Piper Aircraft Corporation
2926 Piper Drive
Vero Beach, Florida, U.S.A. 32960

SERVICE No. 967 BULLETIN

DATE: January 24, 1994

Aileron Hinge Inspection and Replacement

SKETCH A

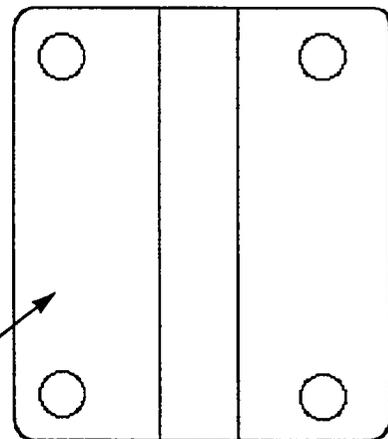
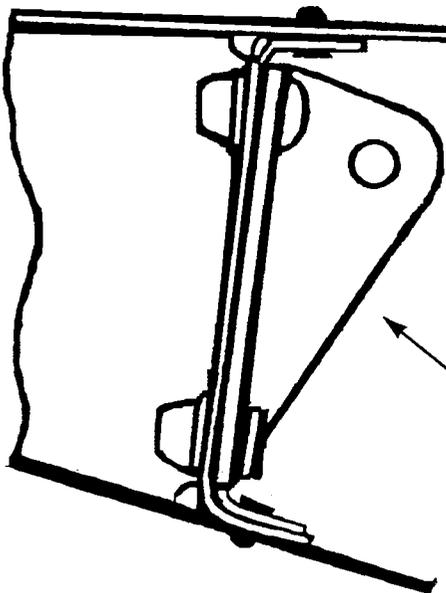
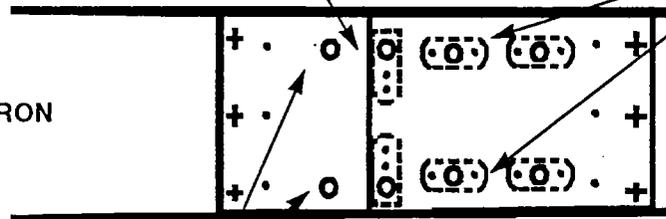
Reports have been received indicating that small cracks are developing in the aileron spar and reinforcement doubler beneath the inboard aileron hinge attachment point.

3. Inspect area beneath the inboard hinge on the aileron spar for cracks. If cracks are not visually observed, use a suitable dye penetrant method for inspection.
4. If no cracks are found, re-inspect in accordance with the compliance time indicated. If a crack is found proceed to Instruction 5. If the time limit of one thousand (1000) hours time in service is reached with no cracks, proceed to Instruction 7.
5. If the aileron spar is cracked, inspect the rib just behind the hinge for signs of cracking. If the spar assembly and/or rib are cracked, replace them before proceeding further. Refer to the appropriate Parts Catalog for applicable part numbers.

INSPECT:
CRACKS WILL
APPEAR ALONG
SPAR FLANGE
AND AT ATTACH
HOLES.

ADD HOLES & NUTPLATES

EXISTING HINGE HOLES

INSPECT:
CRACKS WILL
APPEAR ALONG
SPAR FLANGE
AND AT ATTACH
HOLES.

6. Install the new Hinge Bracket, Piper Part Number 74461-02 (left) and 74461-03 (right) utilizing three (3) each AN3-5A Bolts, Piper Part Number 401-266, three (3) each AN960-10 Washers Piper Part Number 407-564, and one (1) each MS24694S53 Flush Screw, Piper Part Number 410-035, per Hinge Bracket.

7. If no cracks are present, it will be necessary to drill additional holes and add two (2) additional nutplates to the existing aileron spar assembly. Align and clamp new hinge brackets and shim together. Mark and drill shims to match hinge brackets. Temporarily install new hinge bracket and shim to aileron spar. Using the new hinge bracket and shim as a template, drill two (2) new .191 inch holes in the spar to match.
8. Remove enough rivets from the aileron skin to gain access to the inside of the aileron.

INSTALL NEW HINGE
P/N'S 74461-02 (LEFT)
AND 74461-03 (RIGHT)
